**CITY OF KIRKLAND**  
**Planning and Community Development Department**  
**123 Fifth Avenue, Kirkland, WA 98033 425.587-3225**  
[www.kirklandwa.gov](http://www.kirklandwa.gov)

## **MEMORANDUM**

**Subject:** Parkplace Amendment Request  
FILE # CAM14-02188

**DRAFT** APPENDIX I: ROAD MAP TO CHANGES

Network of pedestrian connections

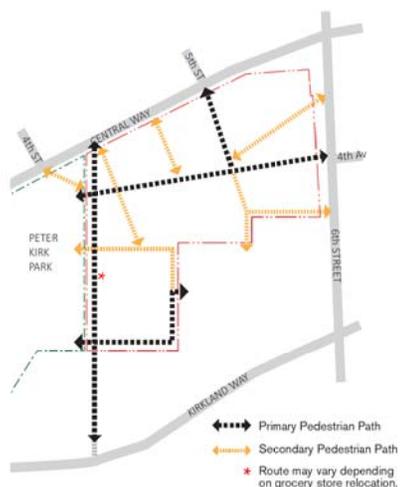
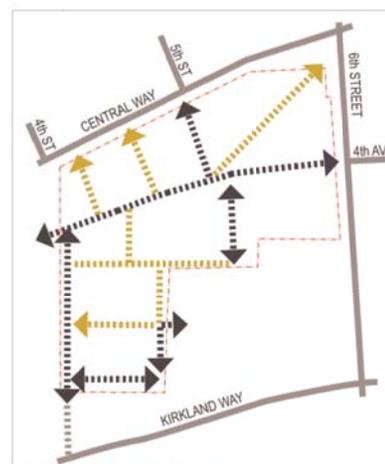
The diagram at right shows approximate pedestrian connections. Darker lines indicate primary connections required designated by the Comprehensive Plan. Lighter lines show secondary connections linking existing proposed streets as well as Peter Kirk Park. These connections are for public use.

The applicant shall work with the City to define appropriate wayfinding strategies between the development and the Cross Kirkland Corridor.

**NOTES ON CHANGES  
& 2008 GRAPHICS TO BE REPLACED**

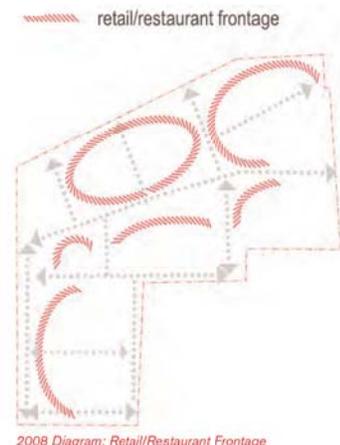
The Retail/Restaurant Frontage diagram is removed. The content of this 2008 diagram is folded into the Organization of Uses diagrams in Section 10.C. Retail frontage is no longer included at the northeast corner of the site. Other activating uses are encouraged there instead.

Section 10.C Organization of Uses is new to the 2014 document.

**D. PEDESTRIAN SPACE**

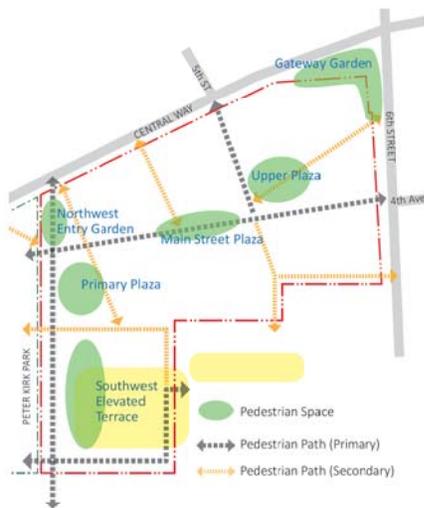
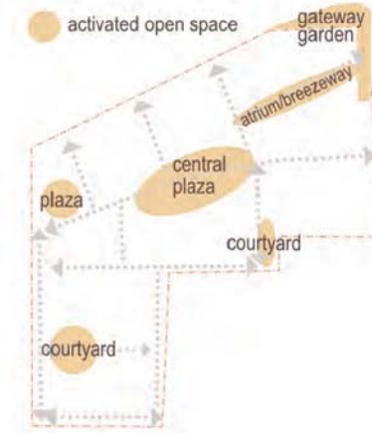
The following types of public/pedestrian space are to be provided at a minimum of 15+0% of the total lot area, or 75,000 ~~50,000~~ square feet. Locations are approximate and not limited to those shown on the diagram at right below:

**3 Park Promenade Section (typical)**

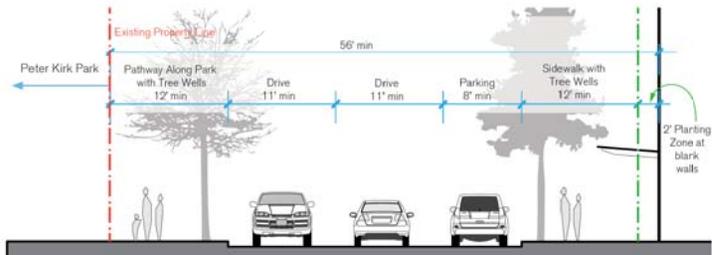
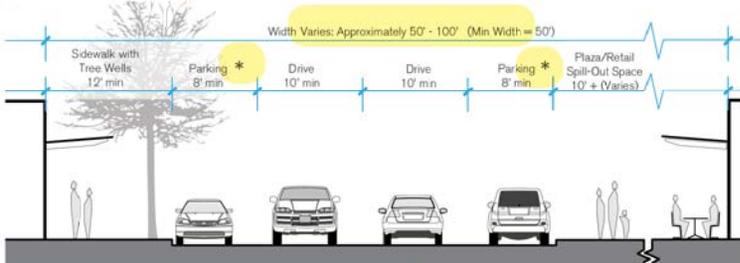
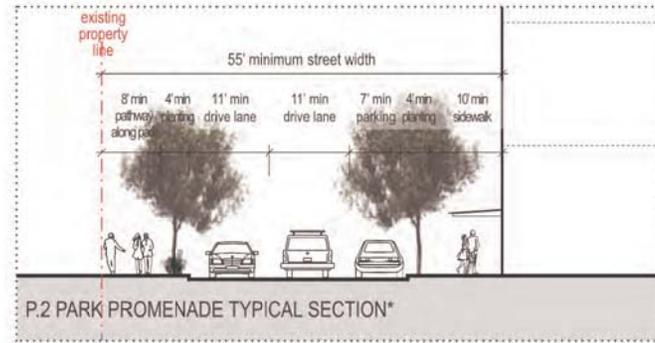
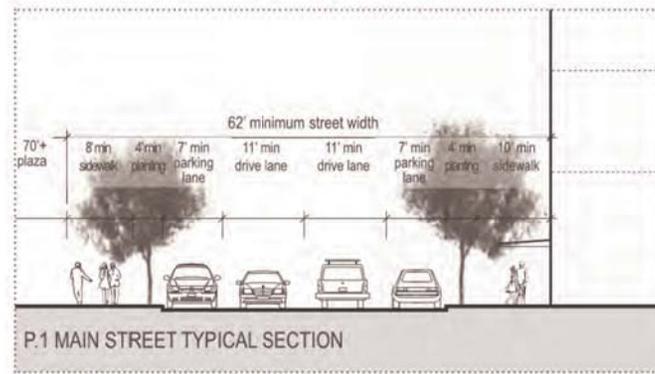
The existing easement to the south shall include a pedestrian sidewalk connecting the Park Promenade with Kirkland Way.

\* The existing easement to the south shall include a pedestrian sidewalk connecting the Park Promenade with Kirkland Way.
